Re: 1,2&O Cleaners Site, 513 South Meridian St, Puyallup, VCP No. SW0646

Responses to Comments in October 2, 2008 Opinion Letter and January 27, 2012 Email

Site Detail and Sampling Locations
Remedial Investigation Data Gap Work Plan
1,2&O Cleaners Site

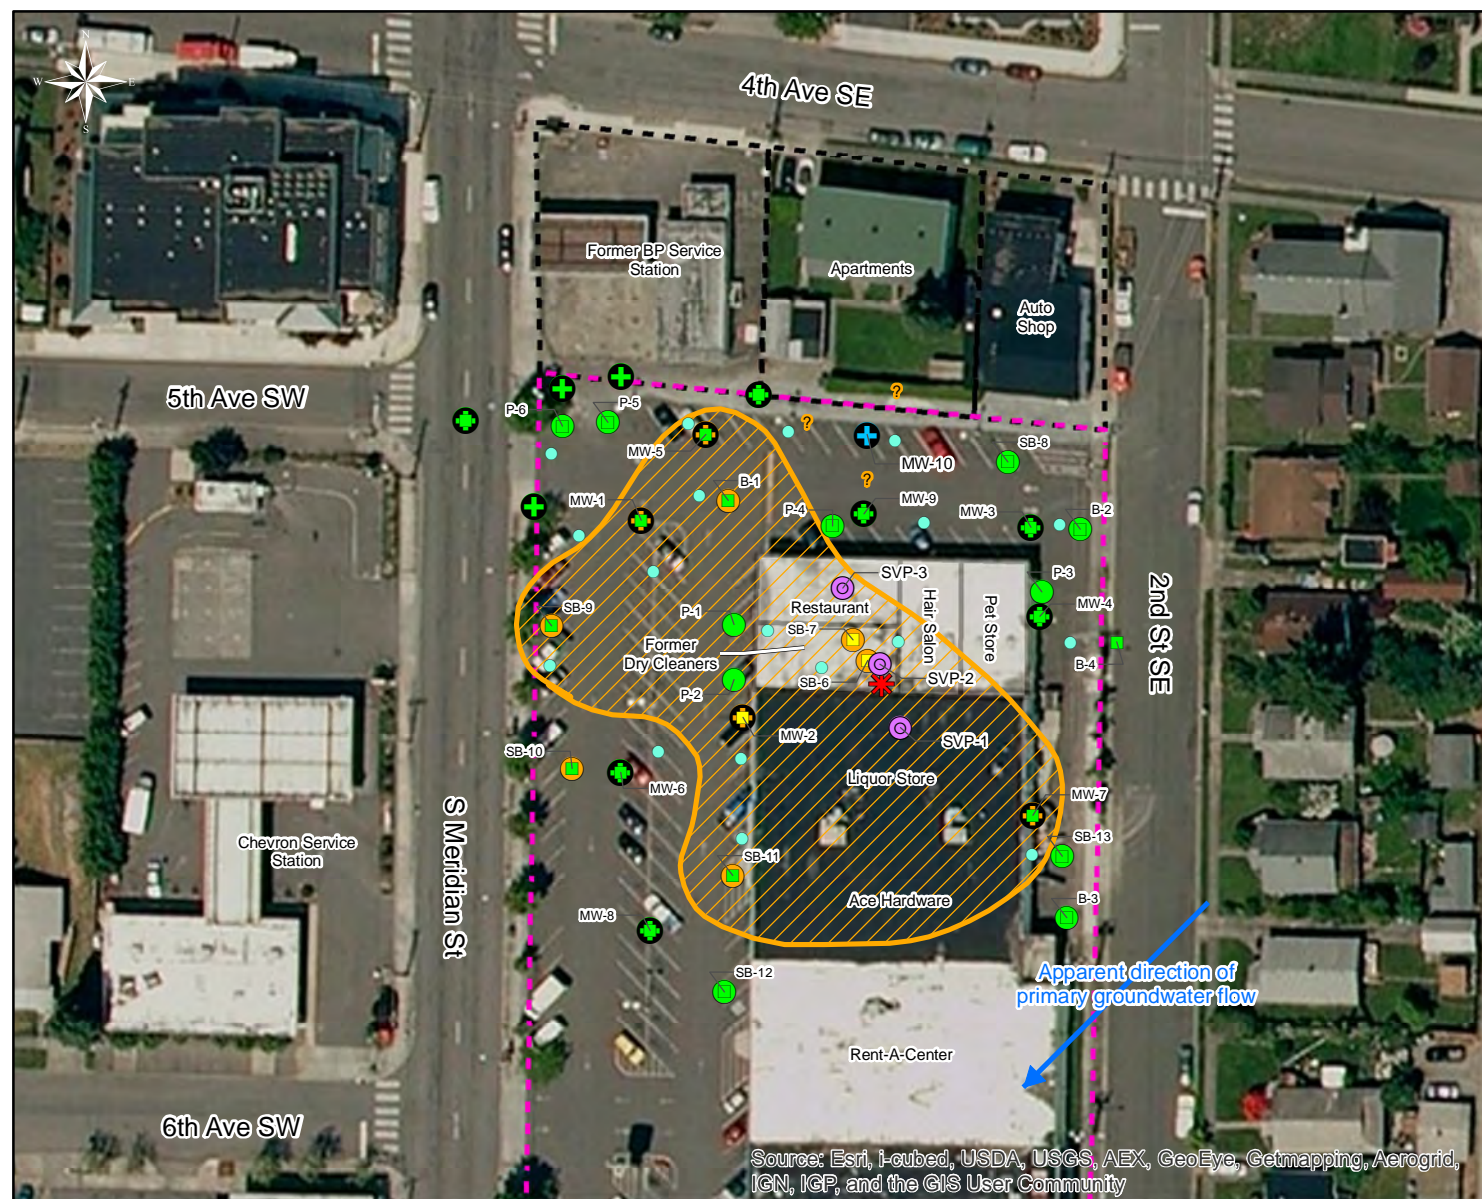
3. Selection of Cleanup Action		Ecology has determined that the cleanup action you proposed for the Site does not meet the substantive requirements of MTCA. The cleanup selected for the Site is soil vapor extraction and enhanced anaerobic bioremediation. While this cleanup alternative may be a viable option for addressing contamination at the Site, the extent of contamination has not been adequately defined as described earlier. As a result, selection of a final cleanup action would be premature at this time until it can be determined what the extent of contamination is, and whether the release from the dry cleaner is commingled with another Site. However, if you choose to do so, it would be acceptable to implement the selected remedy as an interim action in an effort to initiate cleanup in the source area and other known impacted areas of the Site while the remedial investigation is completed.	Comment noted.	Yes. A revised RI/FS Report will be submitted to Ecology following completion of the sampling and analysis proposed in the enclosed RI Data Gap Work Plan.

Figure 1-2

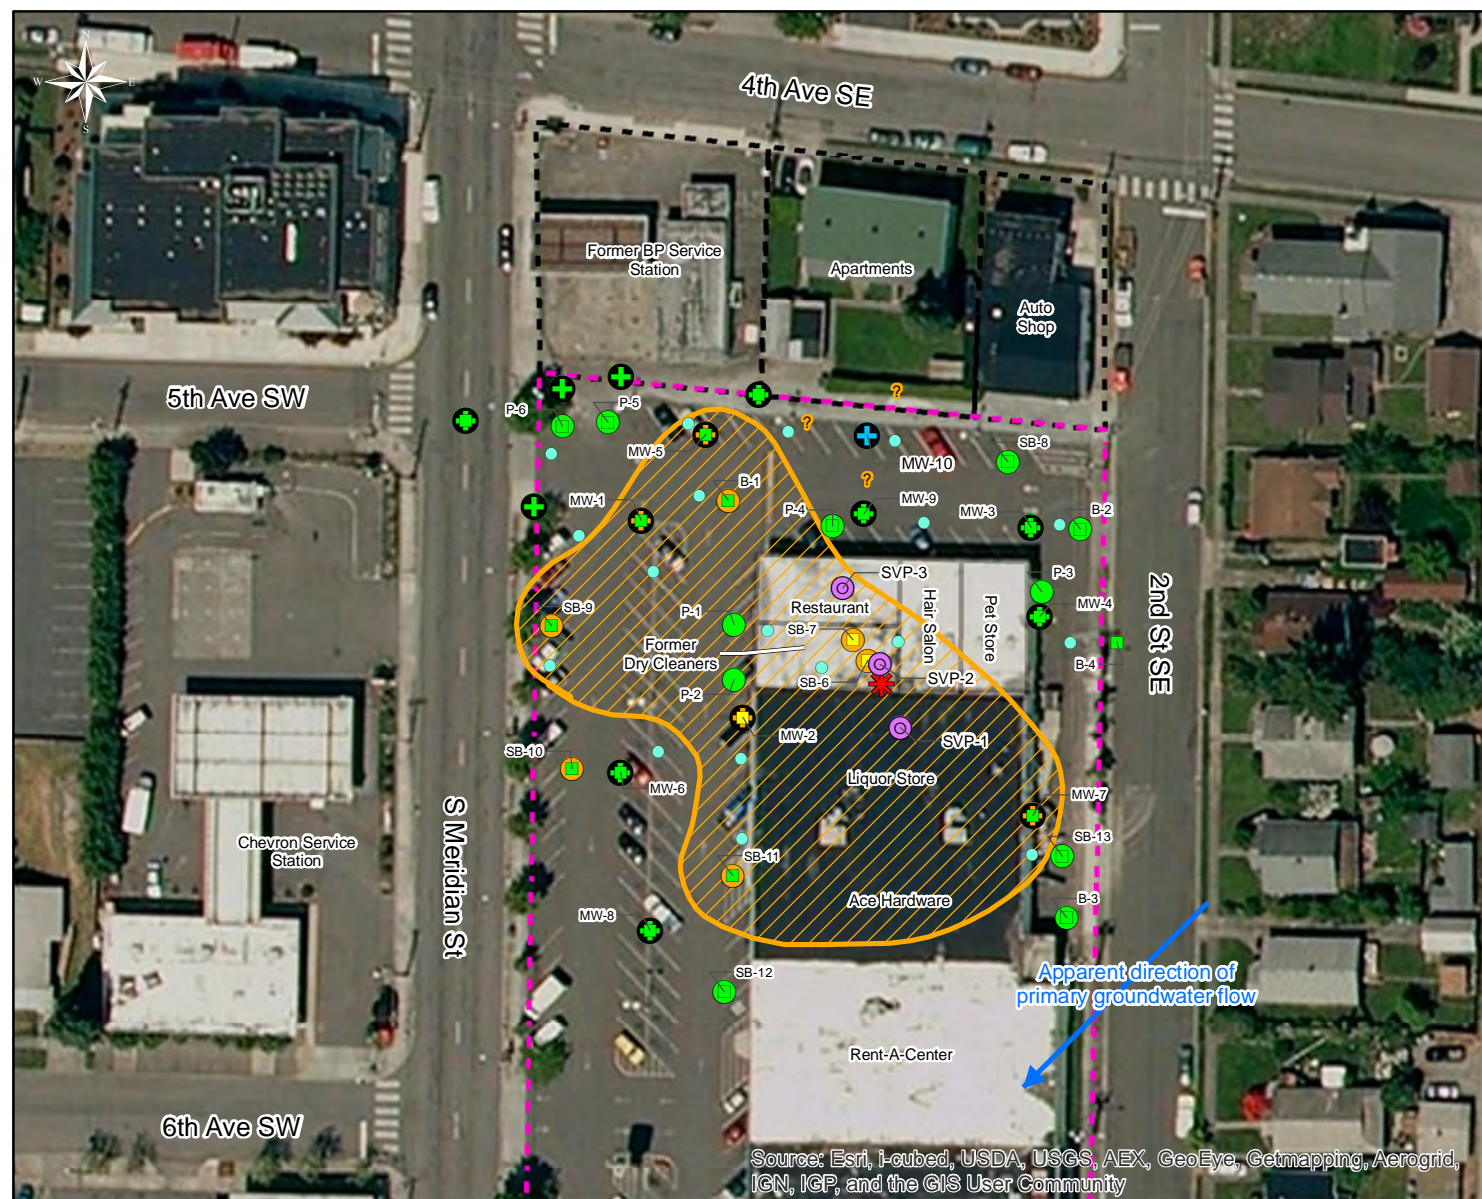
1.3	No soil borings or monitoring wells were advanced in the area of the hot spot along the northern property boundary. This area should be further investigated to support the theory of a second HVOC source.	See response to comment #1.1.	Yes. See response to comment #1.1.

A new MW to be designated as MW-10 will be installed as a "centerline" MW near the suspected source of the suspected second plume to determine if there is a separate plume. The location of the proposed MW-10 is shown in Figure 1-2. The actual MW location may need to be adjusted in the field based on obstructions and access issues, although none are expected. A driller licensed in Washington State per Chapter 173-162 WAC will complete the drilling and MW installation activities in accordance with WAC 173-160 Part II.
